From: Sneeringer, Paul J NAE
To: "Chet Myers"; Jay Borkland
Subject: FW: South Terminal Project in New Bedford - Updated Drainage Swale Drawings (UNCLASSIFIED)
Date: Tuesday, July 31, 2012 11:15:00 AM
Attachments: X-5.2-CROSS SECTION-X-5.2.pdf
P-5.3-P-5.5_SWALE_MITIGATION-P-5.3.pdf
P-5.3-P-5.5_SWALE_MITIGATION-P-5.4.pdf
P-5.3-P-5.5_SWALE_MITIGATION-P-5.5.pdf

Attached please find updated Stormwater Drainage Swale Mitigation Area drawings. This redesign was intended to eliminate net fill in the drainage swale.

NEW BEDFORD MARINE COMMERCE TERMINAL

SHEET TITLE
STORMWATER DRAINAGE SWALE MITIGATION AREA PLANTING PLAN

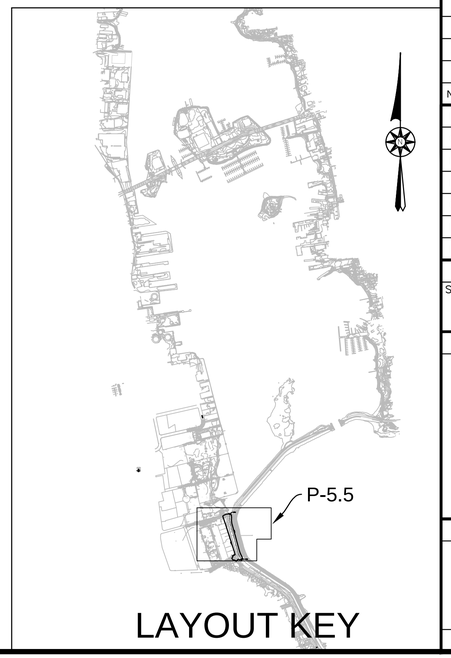
Based upon a review of a couple of the overview maps, it appears that you are seriously curtailing the salt marsh creation/restoration aspect of this work. If this project is suppose to provide compensatory mitigation for the wetland impacts associated with the South Terminal Project, there doesn't appear to be an appropriate size of mitigation at this site only. If this work is not meant to provide compensatory mitigation, why is this work being proposed at all.

During our site investigation of the South Terminal project site last Tuesday, the EPA team noticed an 8-10 foot wide Spartina alterniflora marsh extending along long sections of the western bank of this drainage swale/tidal tributary. This existing marsh does not appear to be documented on any of your REVISED plan drawings. Would this salt marsh bench be impacted as part of the REVISED construction work? If so, these salt marsh impacts should be calculated, avoided if possible, and mitigated if unavoidable. With this issue in mind, I ask you again should this work be simply dropped.
